Randolph Pump Station Improvements Project
Solicitation Number: CO-00459
Job No.: 20-8611

ADDENDUM NO. 6
January 18, 2023

28. Sheet CP-1 Cathodic Protection System Overall Site Plan

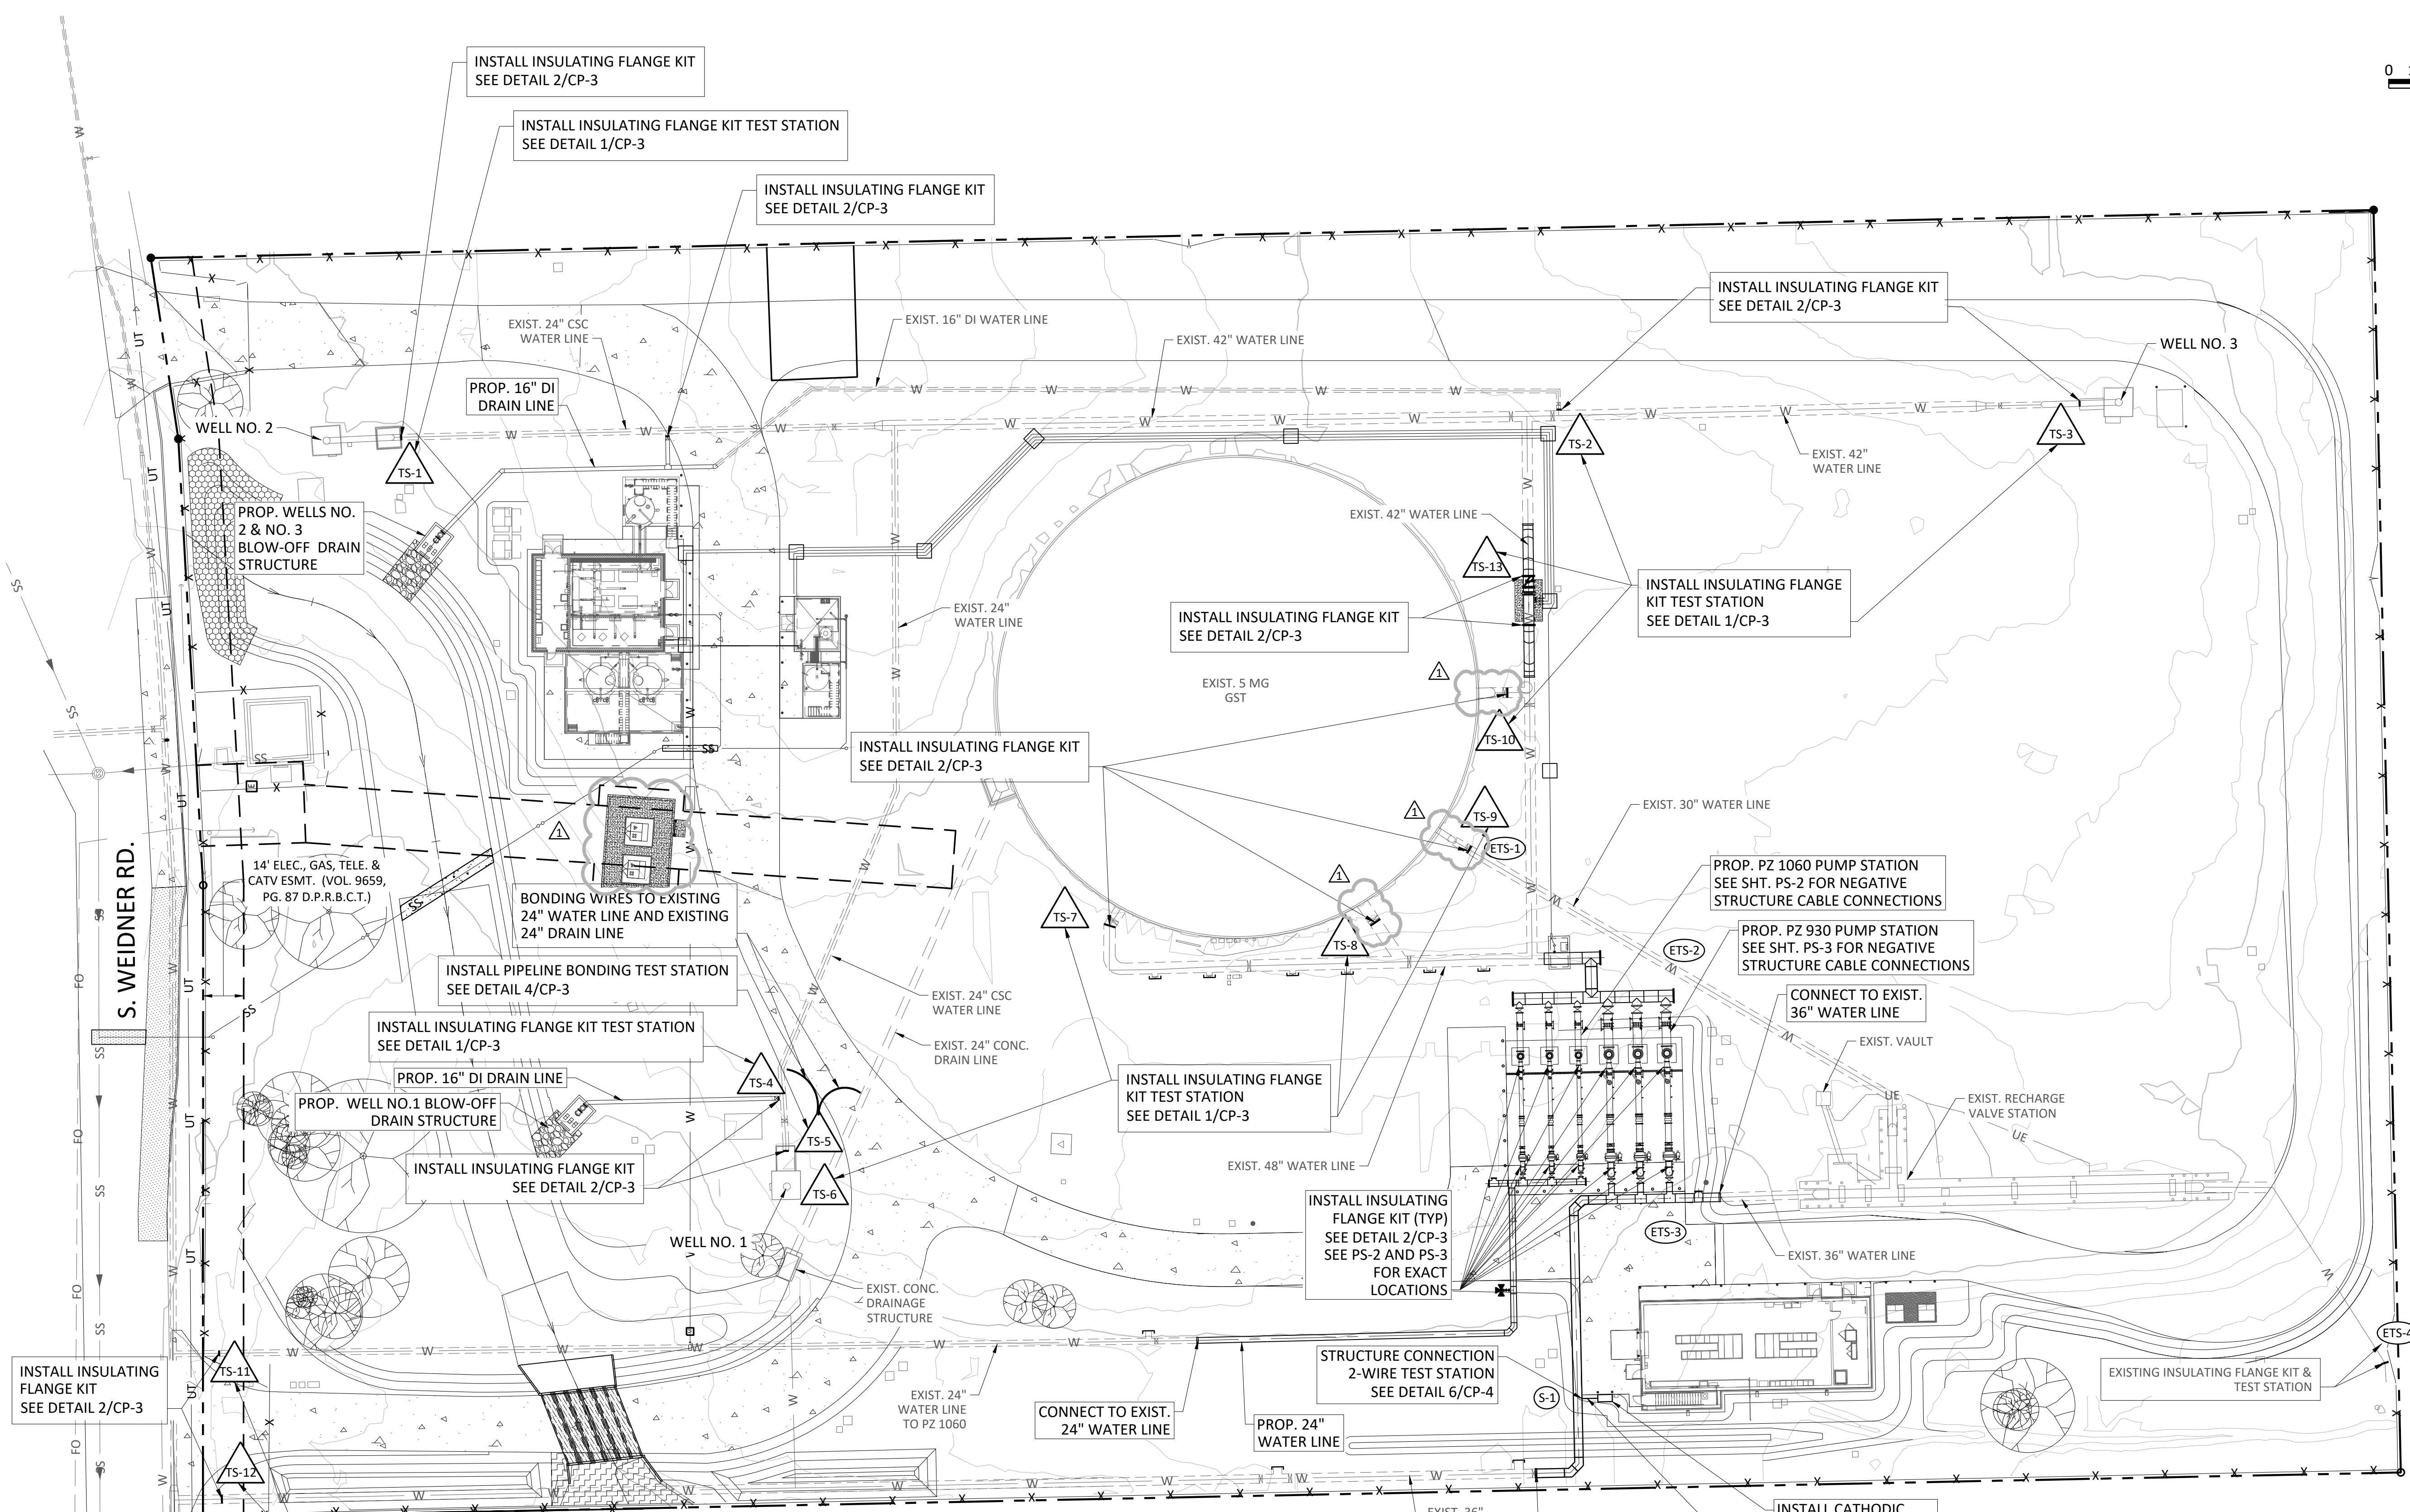
- 2. Question: Sheet CP-1 indicates where to install various cathodic protection. Flange insulating kits TS-8, TS-9 and TS-10 are to be installed upstream of the isolation valves which requires the tank be out of service and drained. Spec Section 01 35 00 does not indicate any allowable timeframe to have the tank out of service. Please confirm how much time the tank can be out of service for the flange insulating kit installations.**

- 3. Question: On Sheet CP-1 Cathodic Protection System Overall Site Plan, at existing 16" DI Water Line tee to existing 42" Water Line (TS-2) what is the depth of the tee, is there an existing flange at the tee and are these lines able to be shutdown for installation of the Insulating Flange Kit?**

5. **Question: On Sheet CP-1 Cathodic Protection System Overall Site Plan, at existing 24" CSC Water Line tee to new 16" Drain Line (Wells No. 2 & 3 Blow-off Drain) what is the depth of the tee, is there an existing flange at the tee and is the existing 24" CSC line able to be shutdown for installation of the Insulating Flange Kit?**

6. **Question: On Sheet CP-1 Cathodic Protection System Overall Site Plan, at existing 24" CSC Water Line tee to new 16" Drain Line (Well No. 1 Blow-off Drain) what is the depth of the tee, is there an existing flange at the tee and is the existing 24" CSC line able to be shutdown for installation of the Insulating Flange Kit?**

Response: Insulating flange kits to be installed downstream of the tank outlet isolation valves and upstream of the tank inlet isolation valve. See Item Nos. 2, 3 and 28 in the CHANGES TO THE PLANS section of this addendum. For updates to allowable shutdowns and critical operations, see Item No. 1 in the CHANGES TO THE SPECIFICATIONS section of this addendum.

Response: Depth of tee is approximately 5'. There is an existing flange at the tee that can be used for the tie-in connection. See Item No. 1 in the CHANGES TO THE SPECIFICATIONS section of this addendum for updated Section 01 35 00 that describes allowable shutdowns of the existing wells.

Response: Depth of tee is approximately 10'. There is an existing flange at the tee that can be used for the tie-in connection. See Item No. 1 in the CHANGES TO THE SPECIFICATIONS section of this addendum for updated Section 01 35 00 that describes allowable shutdowns of the existing wells.

Response: Depth of tee is approximately 6'. There is an existing flange at the tee that can be used for the tie-in connection. See Item No. 1 in the CHANGES TO THE SPECIFICATIONS section of this addendum for updated Section 01 35 00 that describes allowable shutdowns of the existing wells.
